## **Oil tanks "WHEEL"**

Rif: NEW-23-011-ING WHEEL 21/07/2023

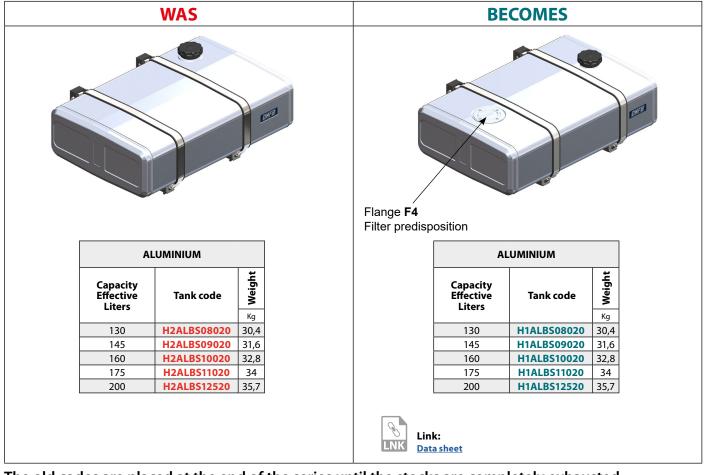
We hereby inform you that the tanks of the "WHEEL" range undergo a modification that involves the introduction of the F4 deep-drawn flange (4xM8 PCD Ø115) and its cover.

The above update will allow the installation of the new adjustable multifunction filters as well as all the return filters from the suitable sizing that will in any case always be ordered separately as an accessory supplied.
